HISTORIC AND DESIGN REVIEW COMMISSION

May 03, 2023

HDRC CASE NO: 2023-145
ADDRESS: 620 LABOR ST
LEGAL DESCRIPTION: NCB 2957 BLK 1 LOT 27 ODINA PARK SUBD
ZONING: C-1 CD, H
CITY COUNCIL DIST.: 1
DISTRICT: Lavaca Historic District
APPLICANT: Evan Morris
OWNER: KLEBERG SCOTT M JR &
TYPE OF WORK: Exterior modifications, fenestration modifications, amendment to previous design
APPLICATION RECEIVED: April 14, 2023
60-DAY REVIEW: Not applicable due to City Council Emergency Orders
CASE MANAGER: Edward Hall

LABOR ST STUDIO

EXISTING
ELEVATIONS
E/W

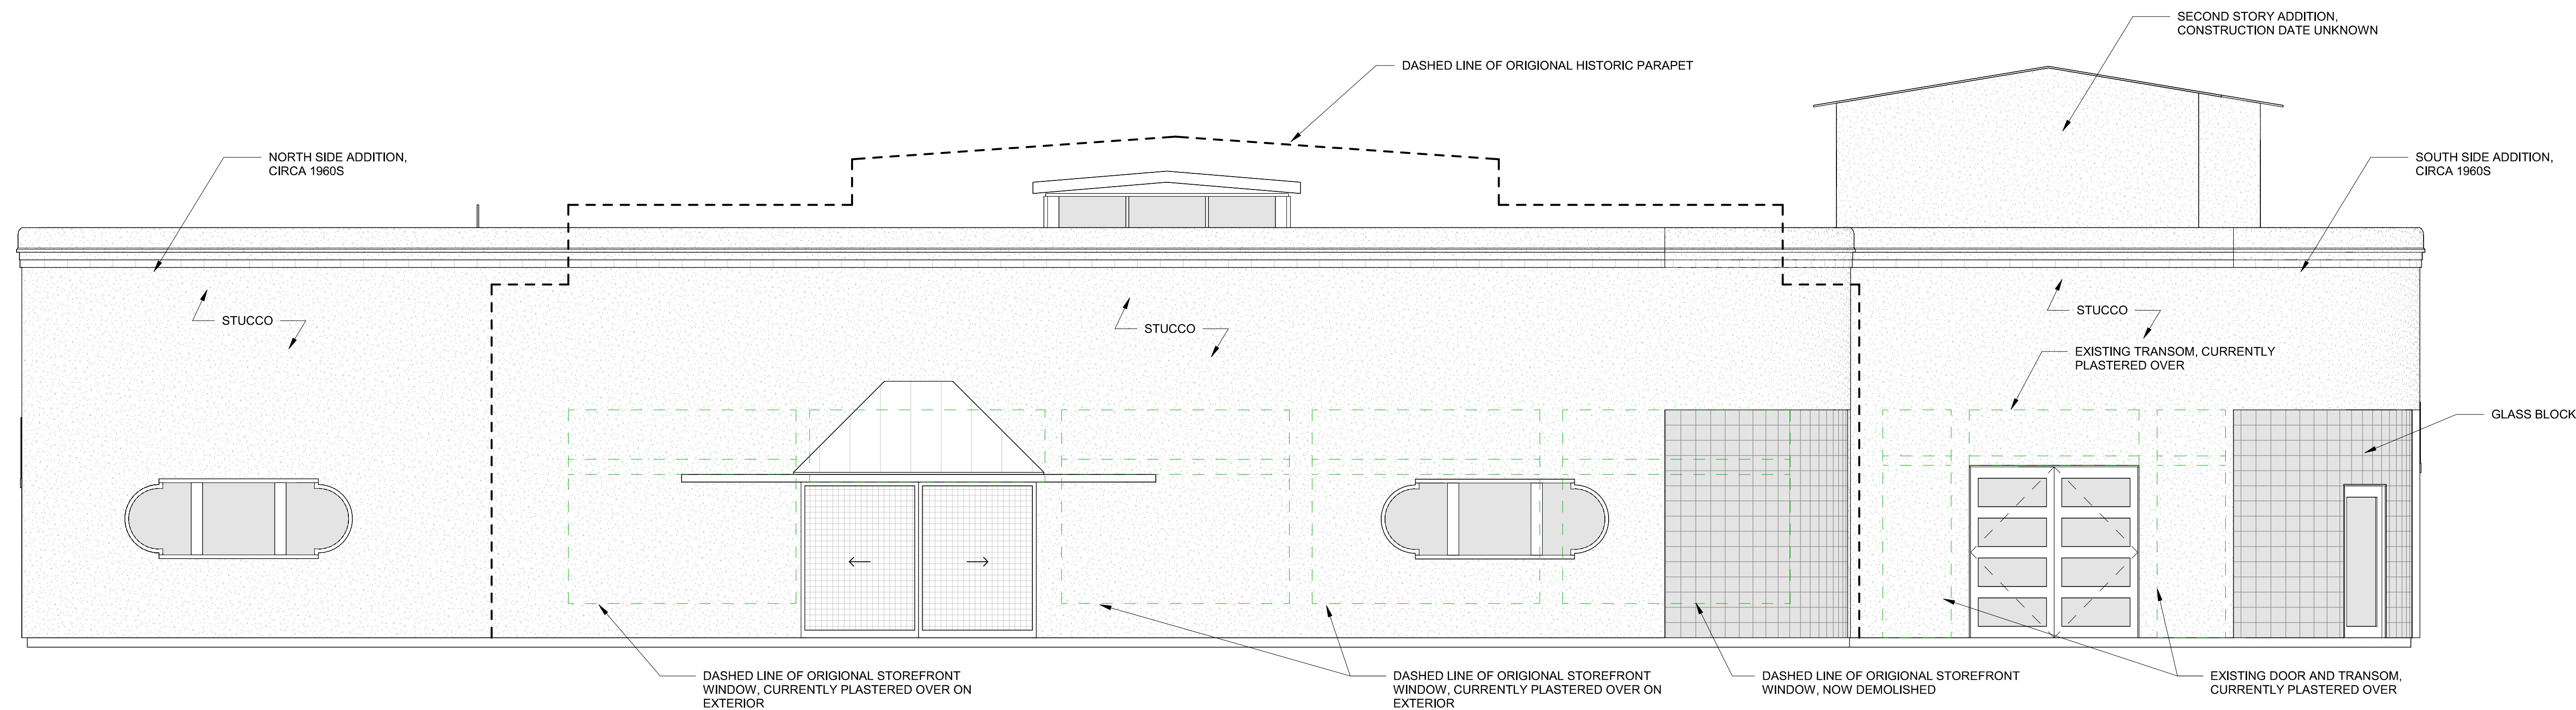
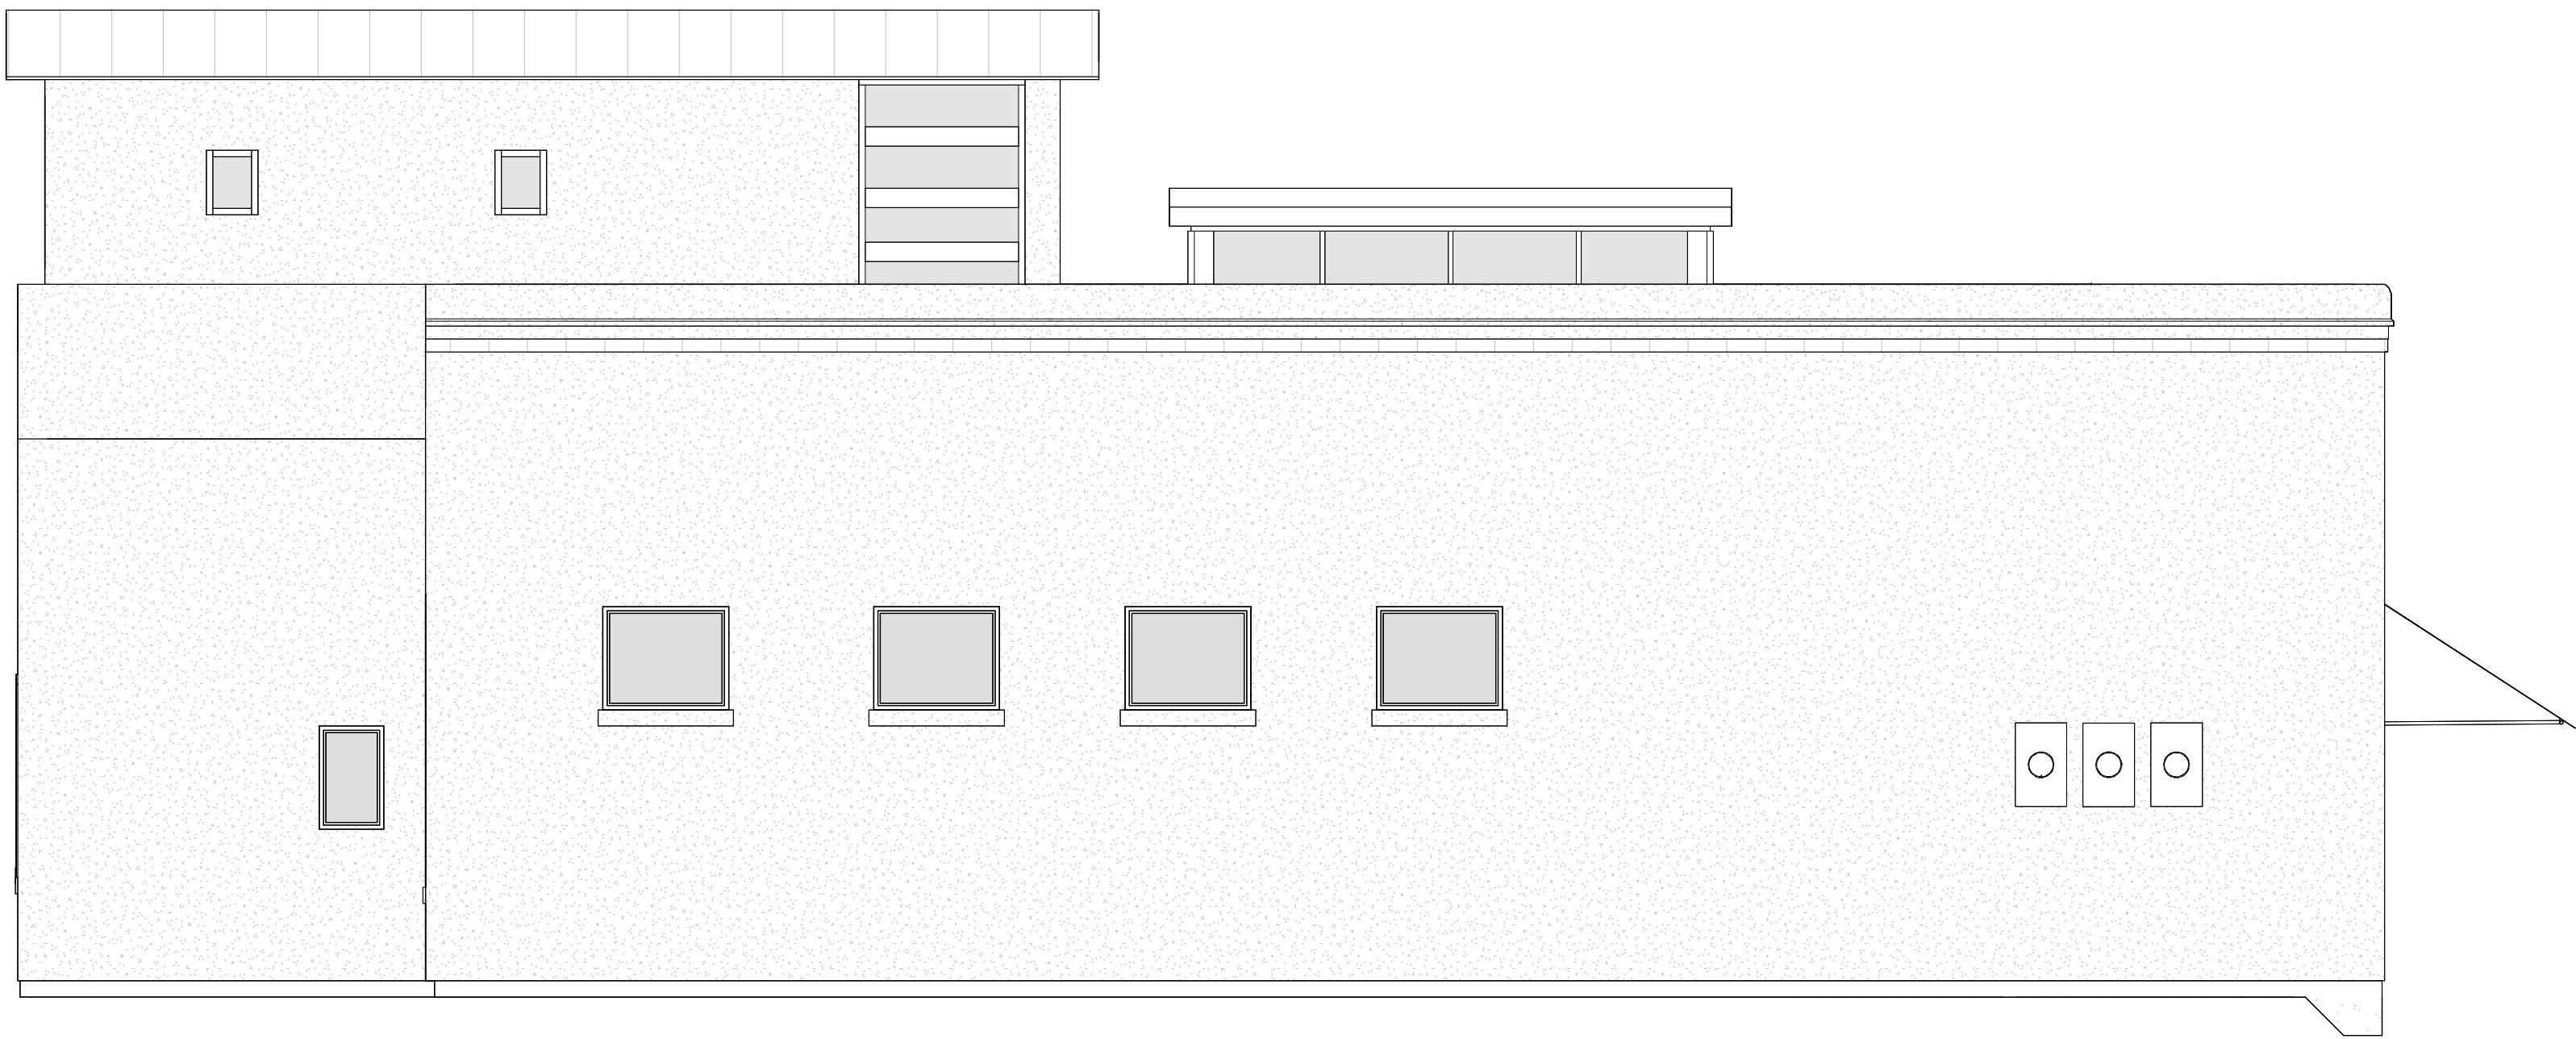
- d. WEST (FRONT) FAÇADE – The structure currently features two (2) circular windows on the west (front) façade. One window was approved to be modified from its original profile to a contemporary storefront profile by the Commission at the October 5, 2022, HDRC hearing. The applicant has proposed to modify the existing, front (west) façade by removing the second circular window and replacing it with a window featuring a contemporary storefront profile to match the previously approved windows. Generally, staff finds the proposed modifications to be appropriate. Additionally, staff finds the use of steel window and door frames to be appropriate; however, all windows and doors are to adhere to the adopted policy guide for replacement windows.

- e. EAST (REAR) FAÇADE – The applicant has proposed to modify the rear façade to result in three new openings to match those proposed on the front façade in profile. The applicant has also proposed to install a new window in an existing opening. The proposed modifications are an amendment from the previously approved design; however, staff finds them to be appropriate. Additionally, staff finds the use of steel window and door frames to be appropriate. All windows and doors are to adhere to the adopted policy guide for replacement windows.

PROPOSED
ELEVATIONS
E/W

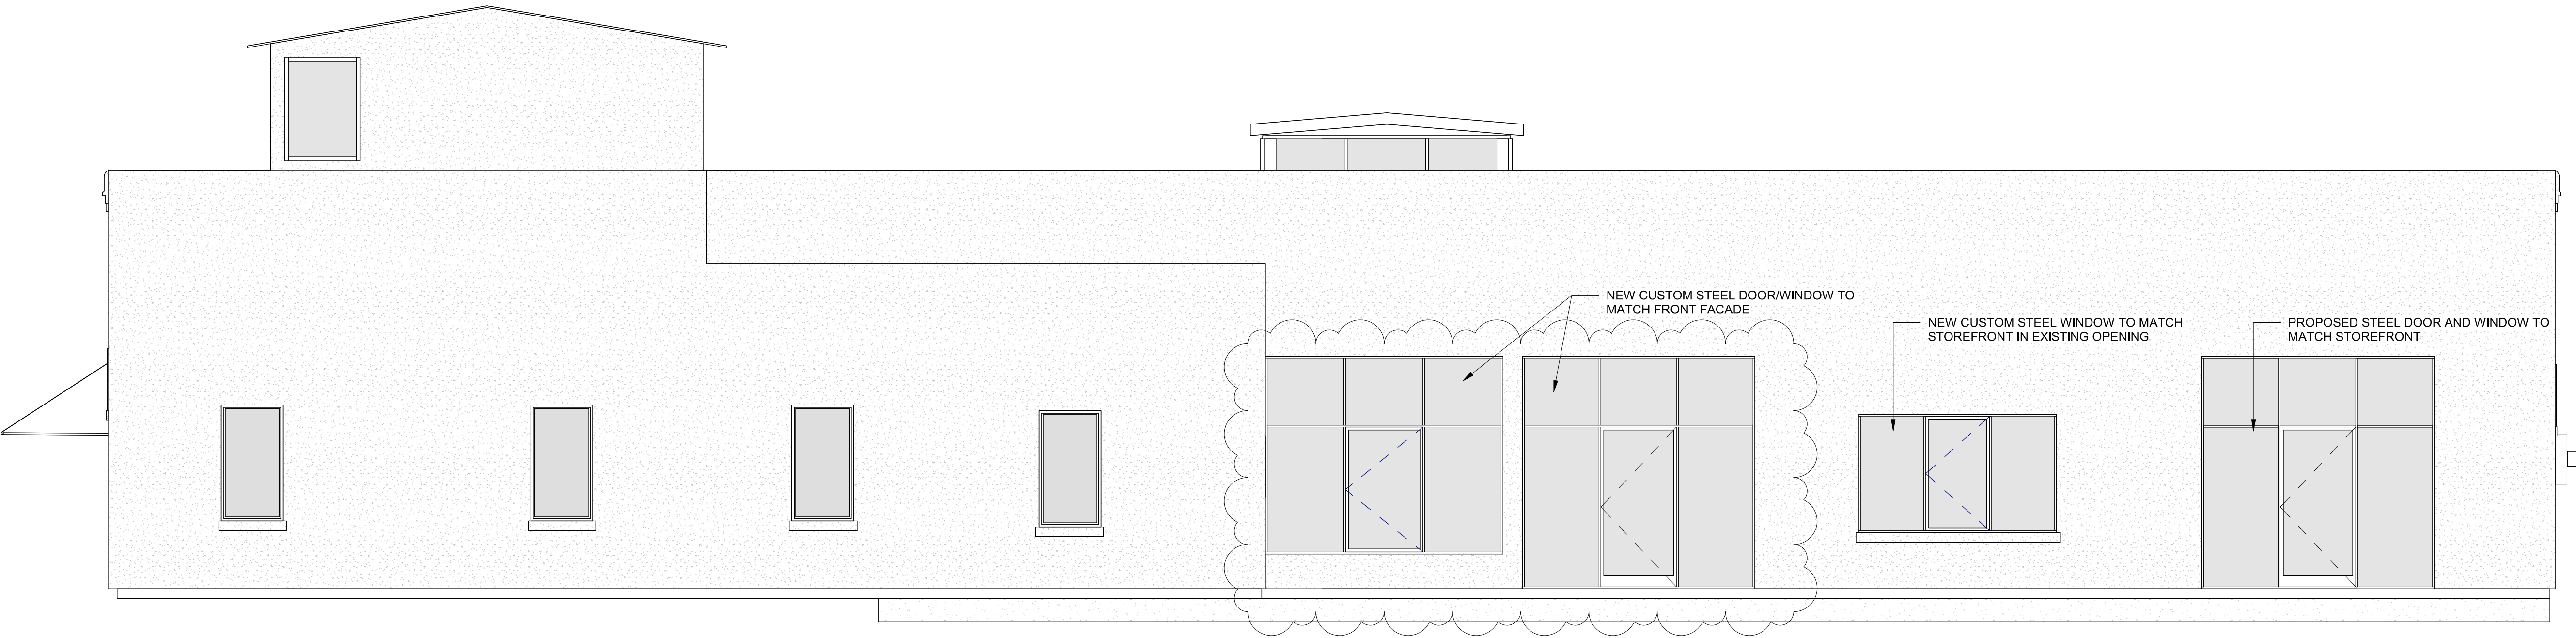
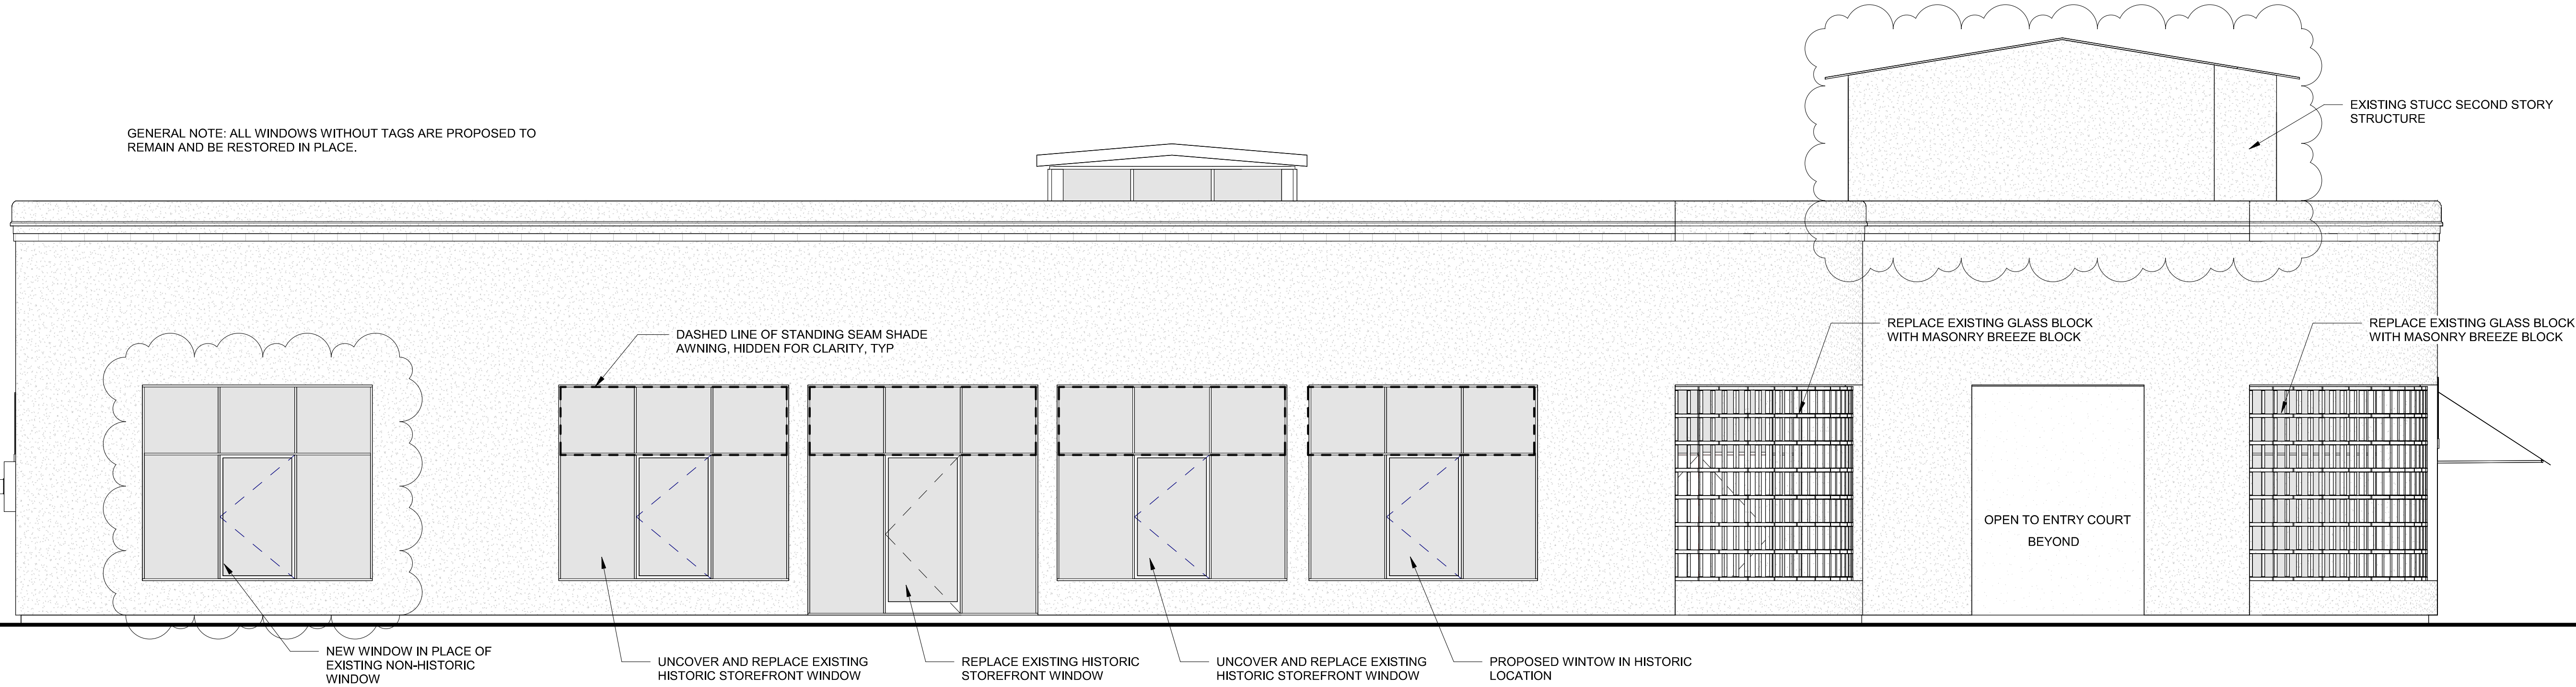
- c. GLASS BLOCK – This structure features non-original glass block in two locations on the front (west) façade. The applicant has proposed to replace the glass block in these locations with masonry breeze block. Both locations are proposed to be open air porches. Generally, staff finds the proposed amendment to be appropriate.

Staff recommends approval of items #1 through #3 based on findings a through e with the following stipulation:

- i. That the applicant submit product specifications and installation details to OHP staff for review and approval of the proposed windows and storefront systems. All new installations are to adhere to the adopted policy guide for windows. All frames are to be dark in color.
